Town of Rolesville, NC

RE: Parker Ridge Construction Infrastructure Plans – **Planning/Zoning Comments**
CID-23-06, 2nd Submittal

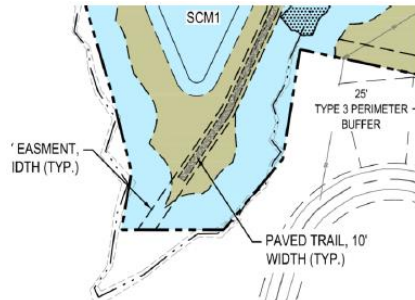
10. New Comment Based Upon Changes to the Plan: The Greenway easement shows that it is not to be constructed/paved all the way (see clip below), despite being in an easement. Please explain in writing the intention here; ultimately defer to Parks & Recreation on the Greenway.

Response: Per our meeting with the parks and rec we have our understanding of environmental permitting, the greenway cannot be constructed through the buffer. P&R will allow a fee in lieu for this portion of greenway.
